Final Drainage Report for Hillpointe Apartments at Peterson

HR Green Project No: 2502477

PCD File No. PPR **2613**

Figure 8-11. Inlet Capacity Chart Sump Conditions , Curb Opening (Type R) Inlet

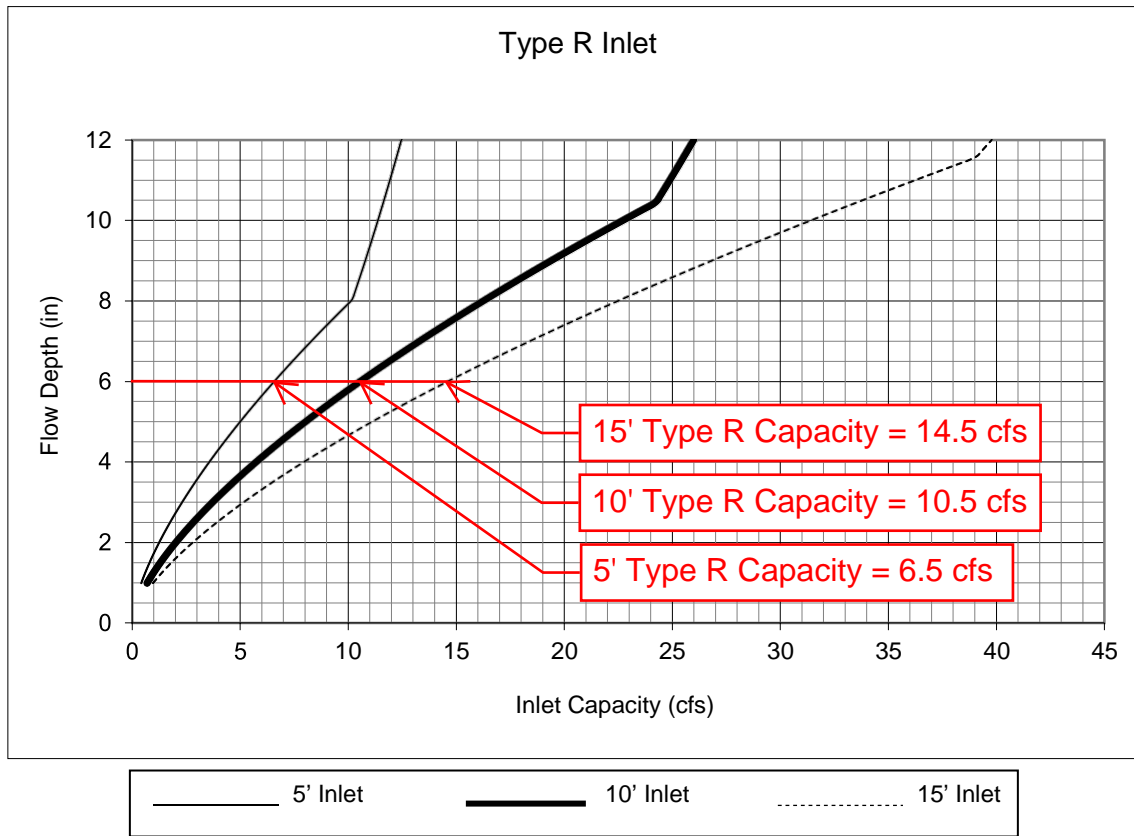
All inlets are sump?

HRG Response:
Yes. Note added.

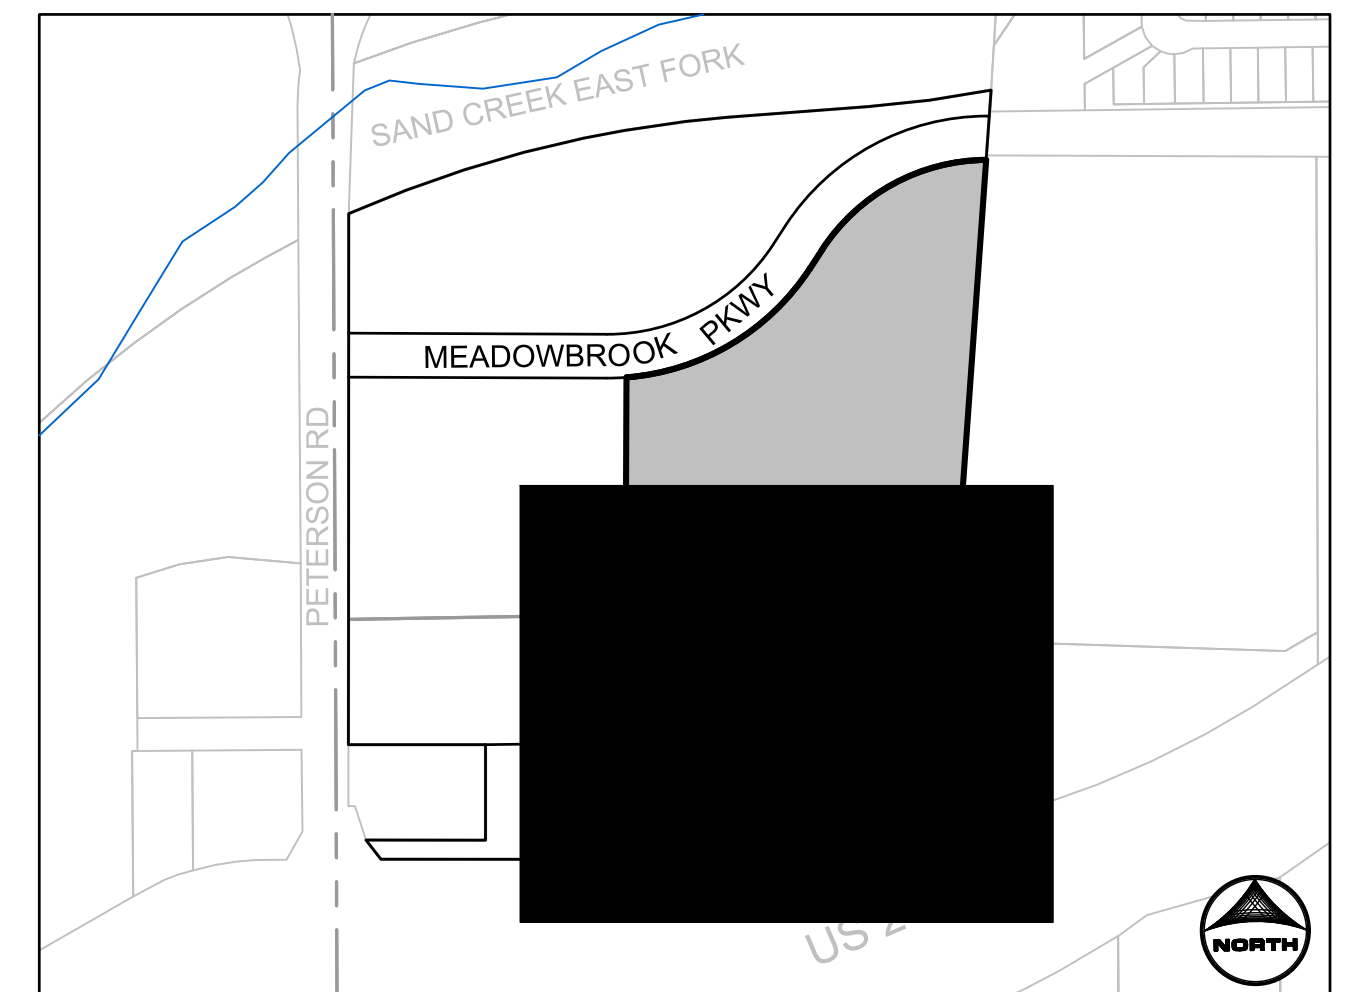
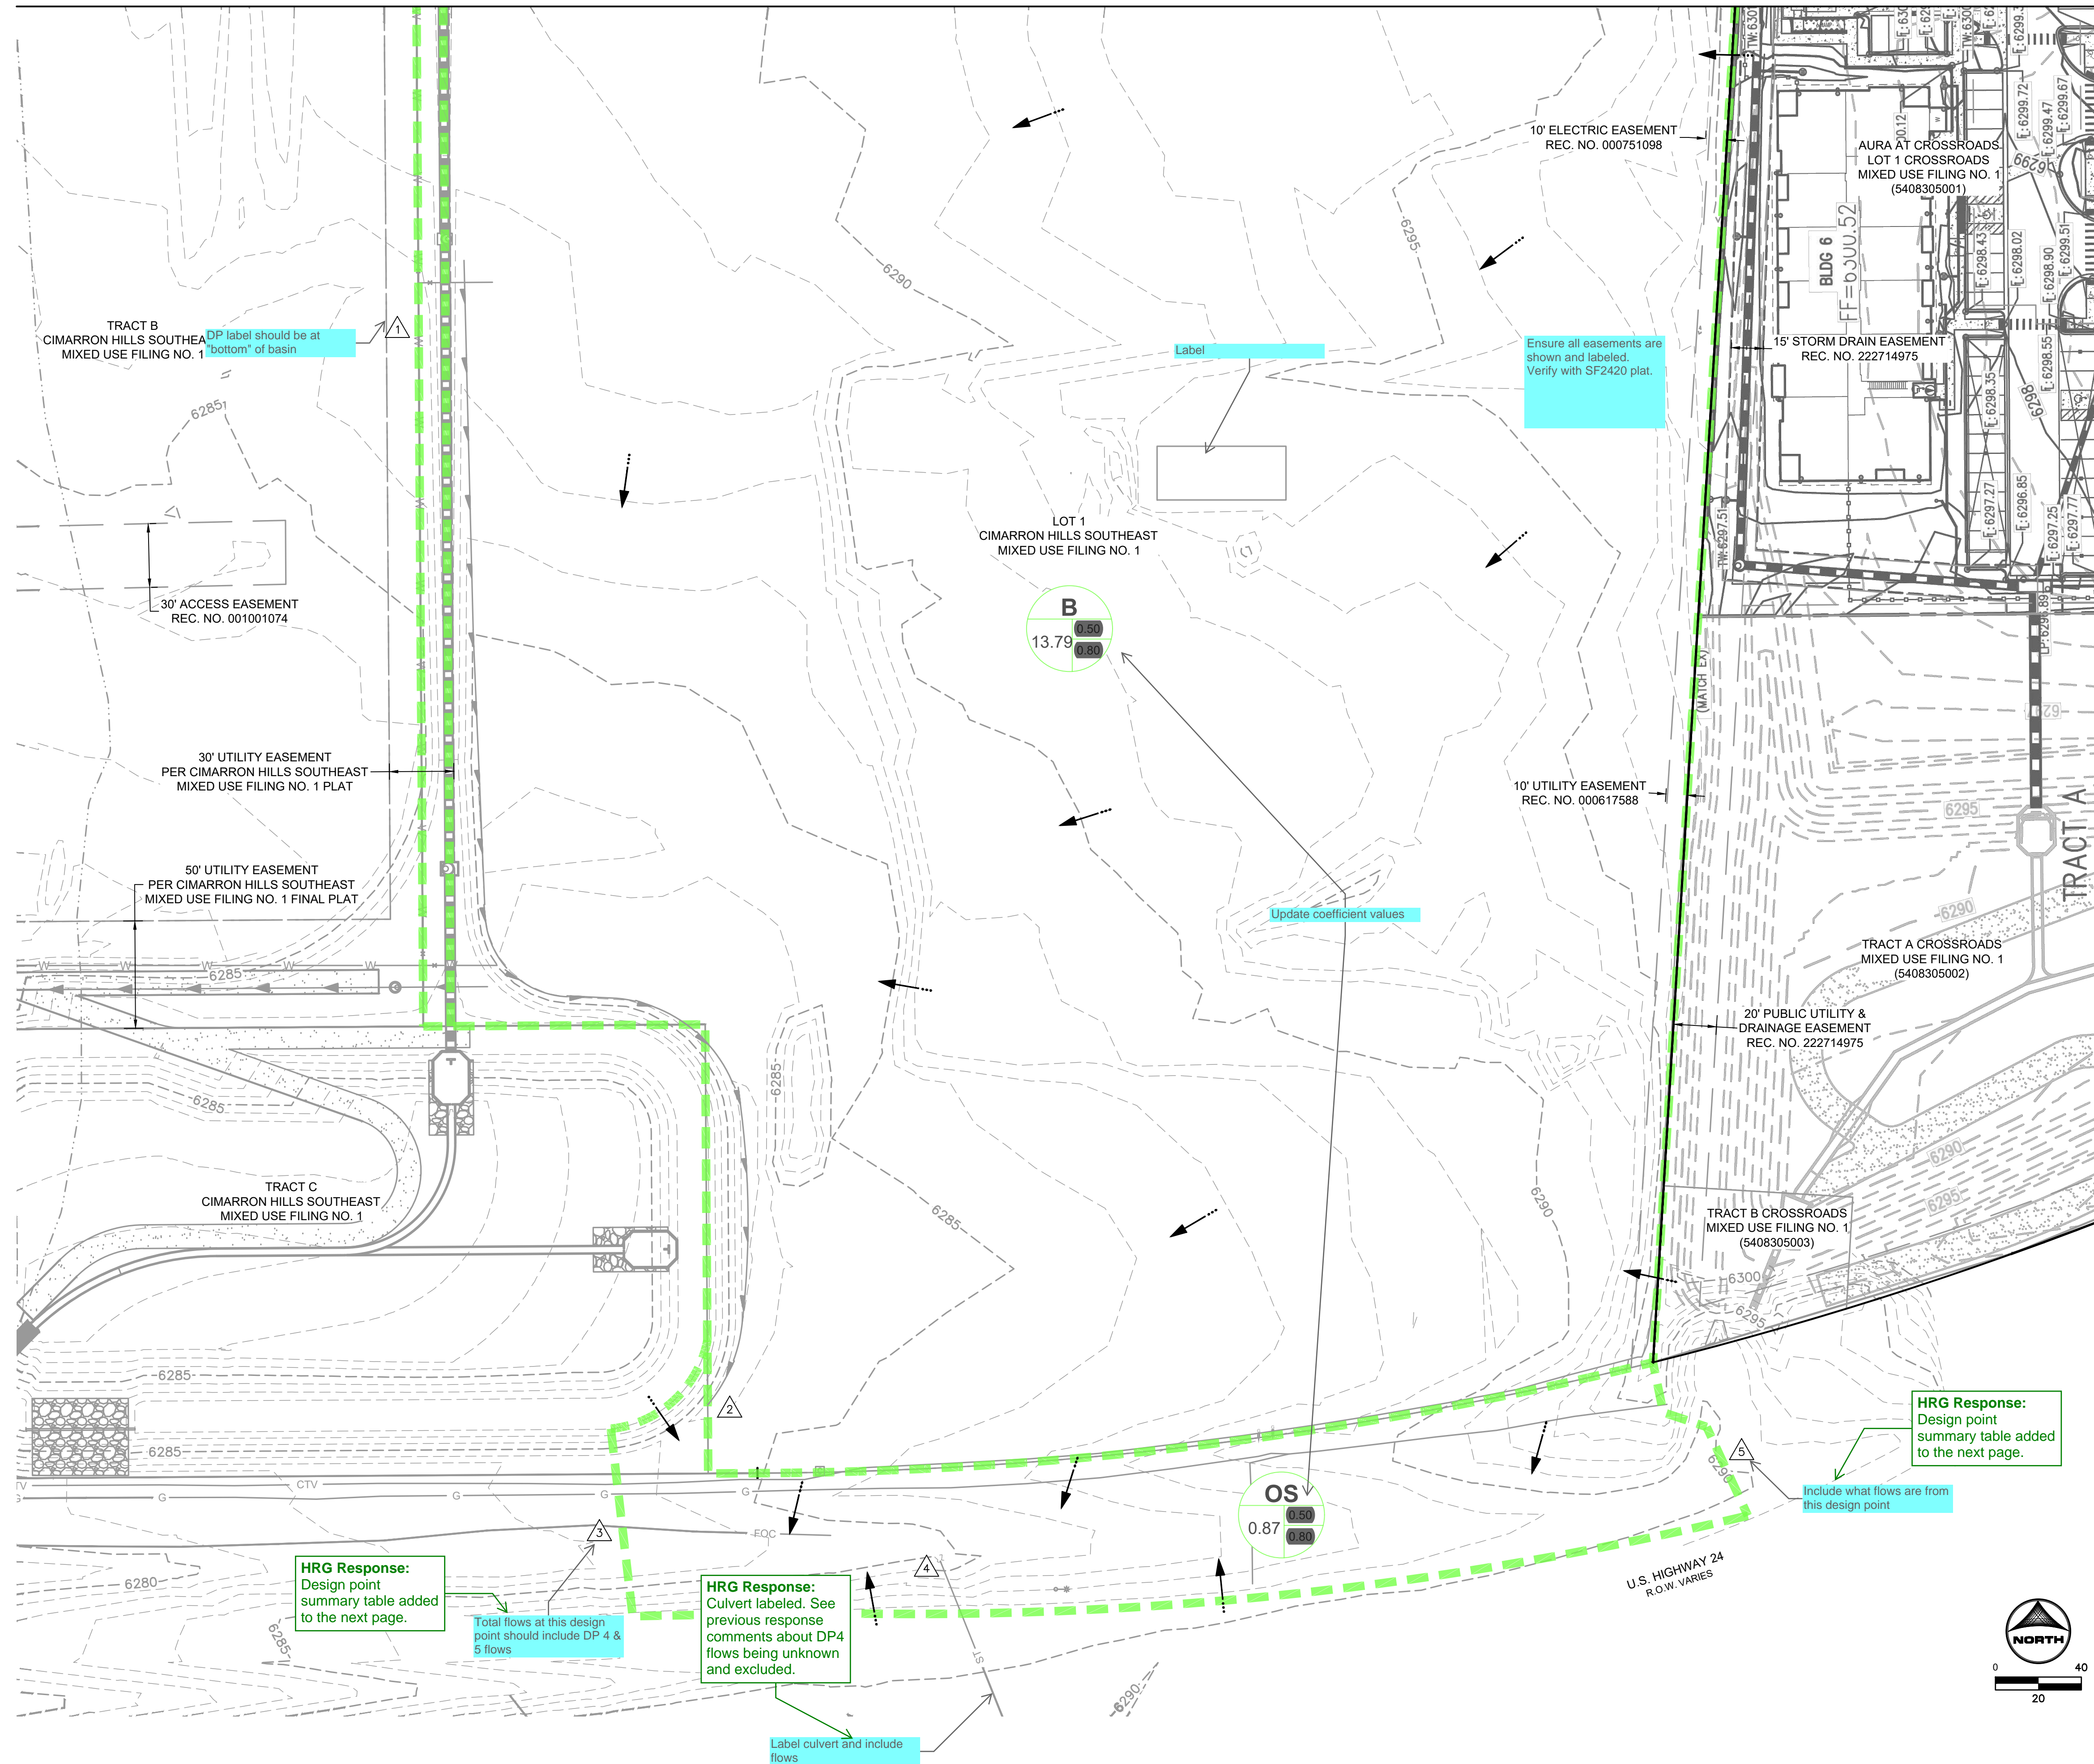
Include MHFD Detention calculations for the final condition of this project (will an updated orifice plate be required?). Also provide forebay and trickle channel calcs.

HRG Response:
Added to Appendix D

FINAL DRAINAGE REPORT
 PROPOSED DRAINAGE MAP
 SHEET DR 4
 PCD FILE NO.:

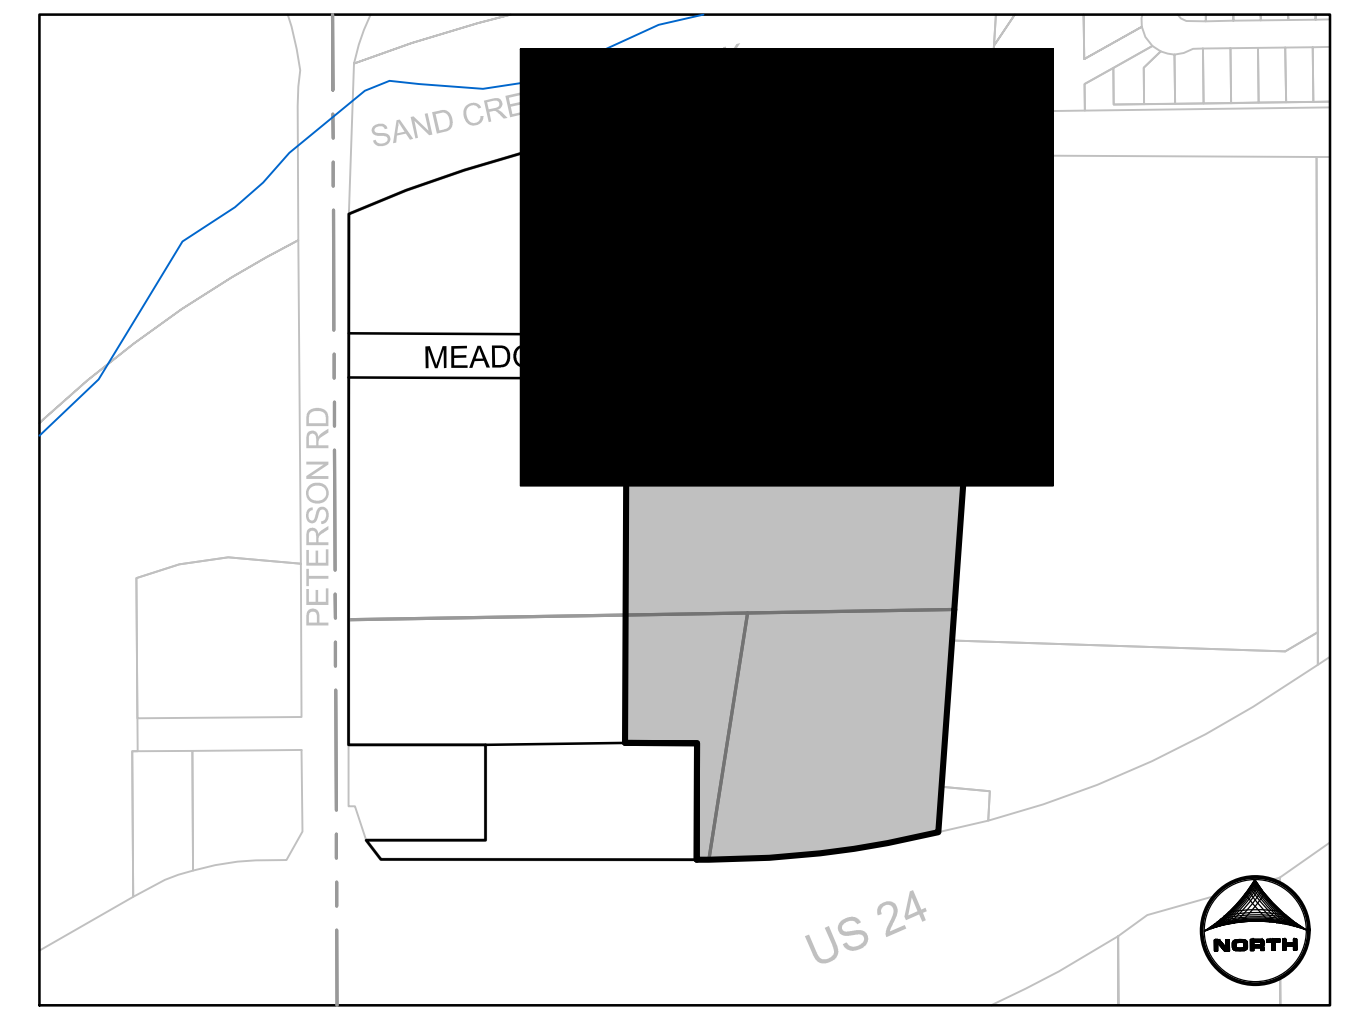
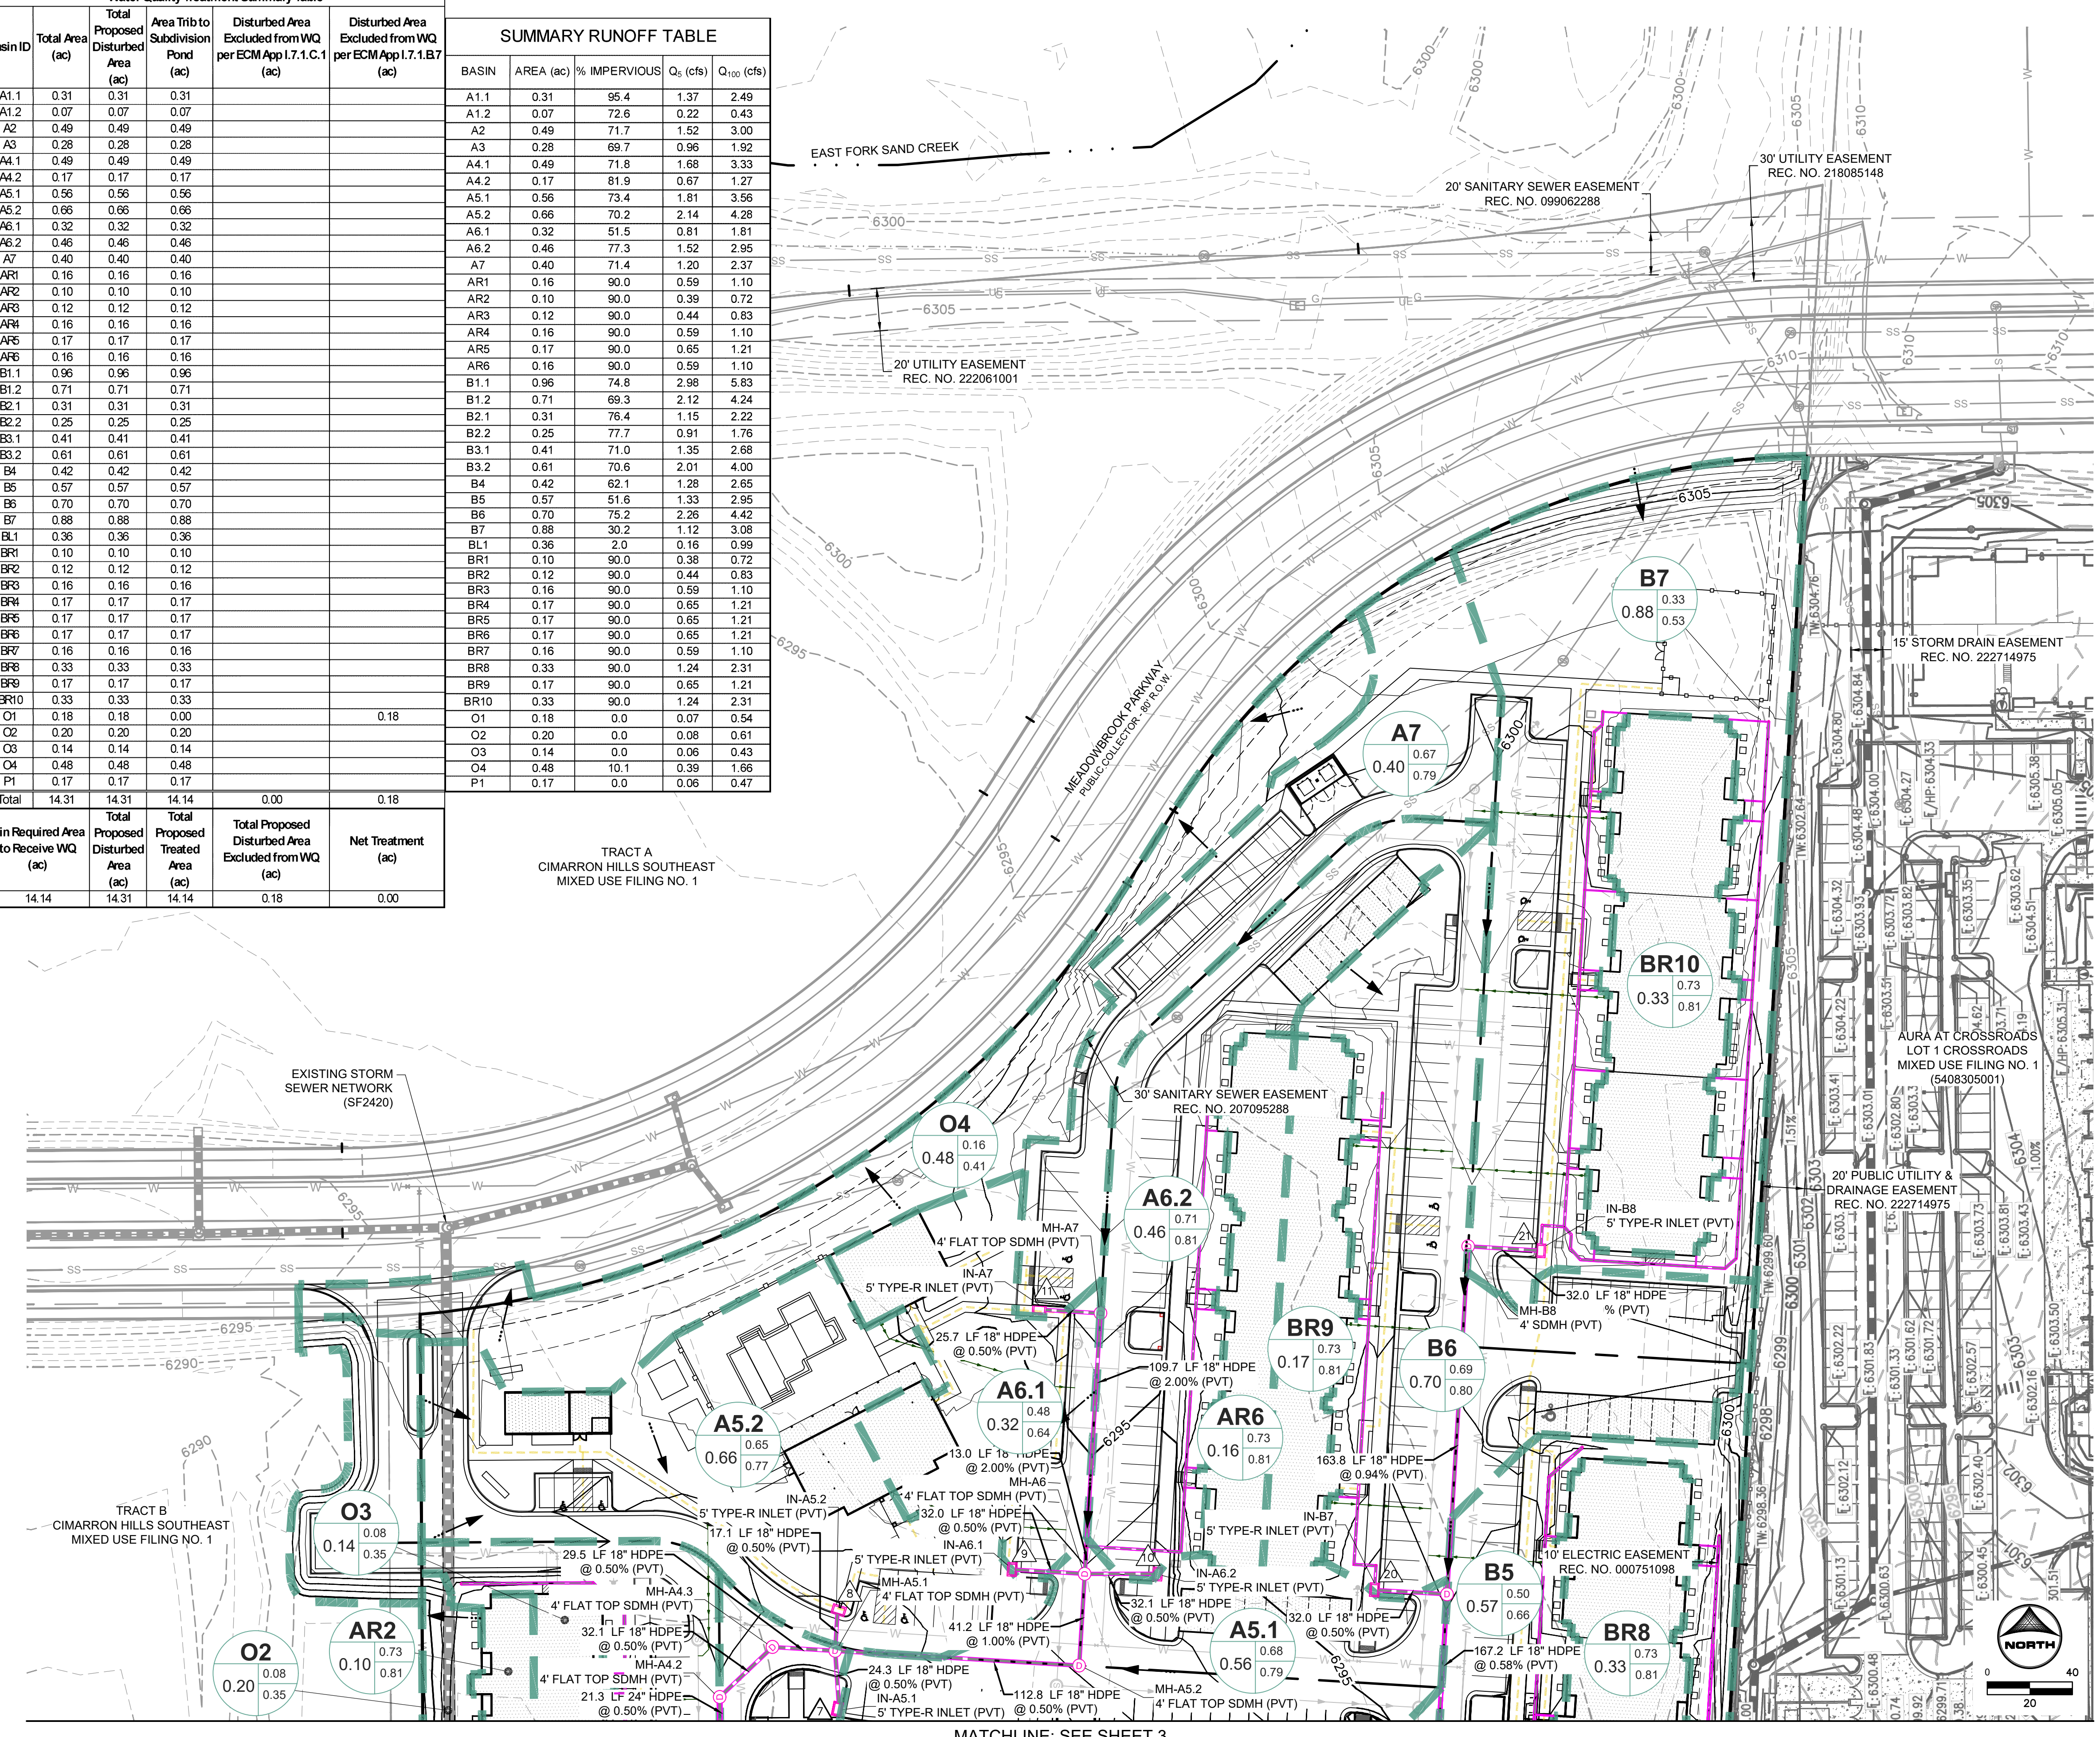
Several of the building basins do not appear to have been taken into account with the design points. See comment in report.

HRG Response:
Basin runoff connected directly to the private storm network analyzed in StormCAD. Design points used for inlets. Discussion of these basins added to report.
